SERVICE BULLETIN

APPLICABILITY: 2012-14MY Impreza 2.0L Models
 2015MY WRX and STI Models

NUMBER: 12-189-15
DATE: 09/23/15

SUBJECT: Rattling Sound from Rear Package Shelf Area

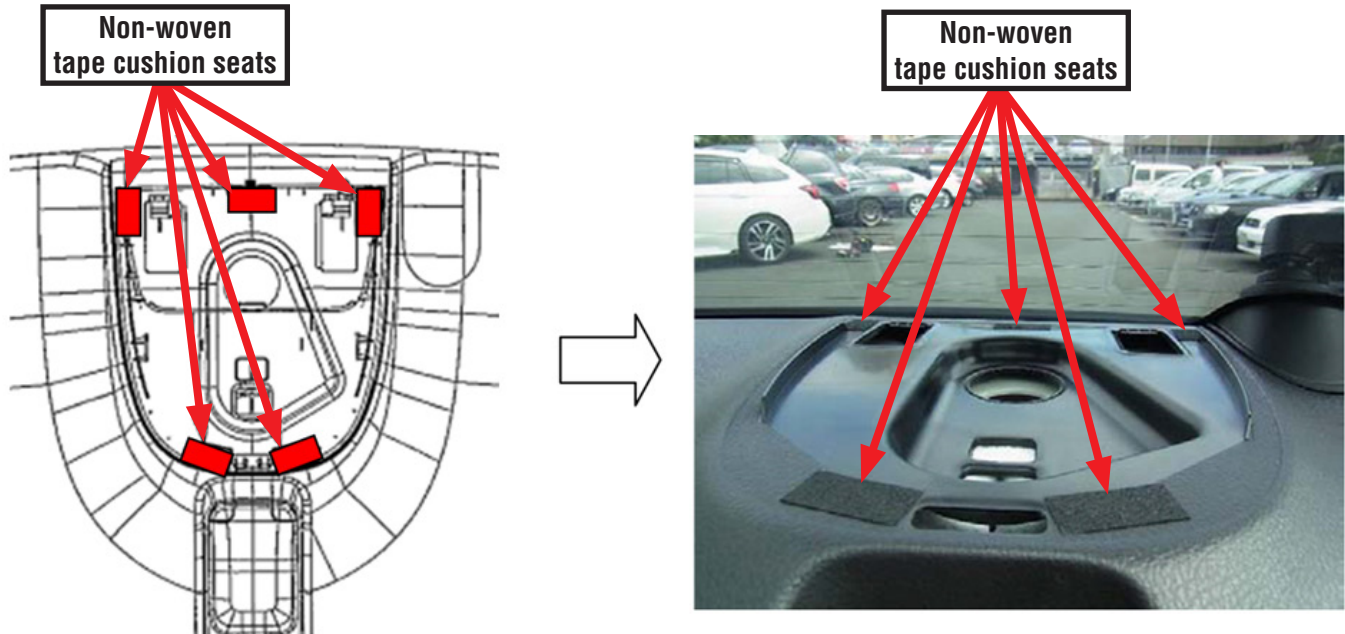
The changes made to the new shelves include:

- addition of 5 non-woven tape “cushion seats” in the area of the center stop lamp
- EPT foam tape added along the rear edge of the shelf to insulate it from contacting the rear glass.

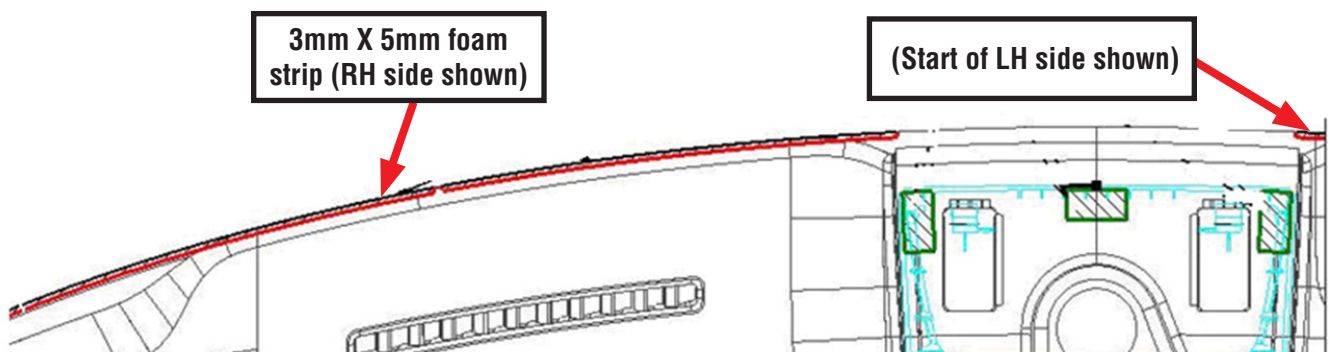
- If the rattle sound is confirmed and determined to be coming from the center stop lamp in the rear package shelf, prepare 5 pieces of non-woven tape material (p.n. **SOA963W110**) 15mm X 30mm. Remove the lamp assembly following the procedure in the applicable Service Manual. Apply the non-woven tape (cushion seats) to the lamp mounting areas of the package shelf as shown in the illustration and photo below. Reinstall the lamp assembly in reverse order of removal.

- If the rattle sound is confirmed and determined to be caused by the rear package shelf contacting the rear glass, order a self-adhesive EPT foam tape “kit” (p.n. **63599AJ000**). Remove the package shelf following the procedure in the applicable Service Manual. Using the 3mm X 5mm X 650mm long strips from the kit, apply the EPT foam tape to the rear edge of the package shelf as shown in the illustration below. Each side will use approximately 600mm of the 650mm long strip. In addition, apply the 5 non-woven tape (cushion seats) as referenced above to the center stop lamp mounting areas of the package shelf at this time. Reinstall the package shelf and center stop lamp assembly in reverse order of removal.
